TECHNICAL SERVICE BULLETIN

WSB-03: Blocked Air Return

WSB-03: Wayfarer Blocked Furnace Air Return

Models Involved: 2020-2022 25RW, 25TW, 25SW, 25LW built between 06/29/2020 and 07/23/2021

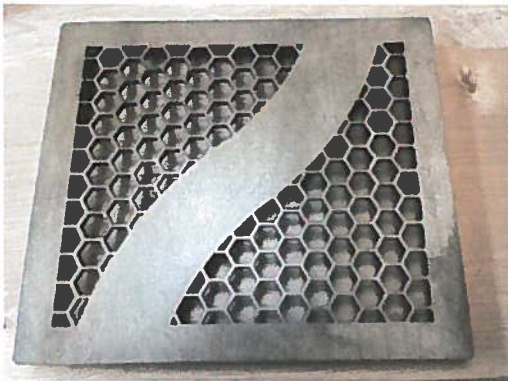
- A. Remove air return insert from the furnace return air opening located directly in front of the furnace by removing the 4 screws, one from each corner of the vent cover.

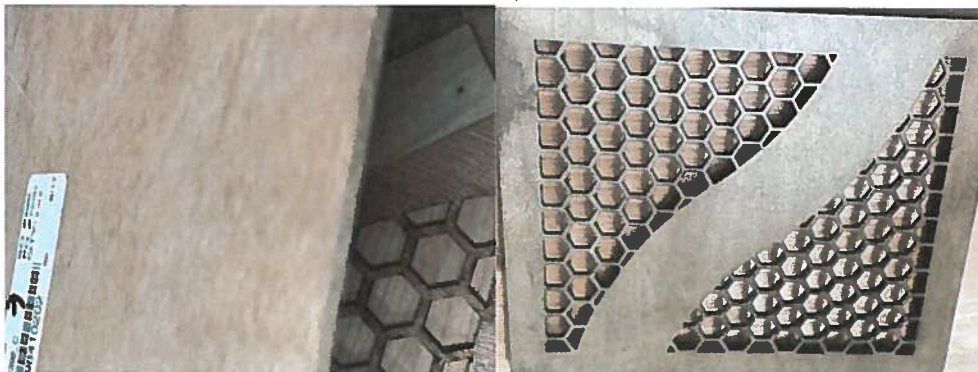
It has come to our attention that some 2020, 2021 and 2022 Wayfarer Motorhomes have an air return that is blocked by a wood panel. If the air return vent is blocked this could cause the furnace to not operate properly which would cause difficulty in heating the motorhome.

- B. Place air return insert face down to expose the two screws located on the backside of the assembly.

- C. Remove the two screws from the back panel on the Air Return Insert in a counterclockwise direction.

- D. Once both screws are removed, remove the panel.

- E. Replace air return insert back into the furnace return air opening and secure it in place with the original screws.
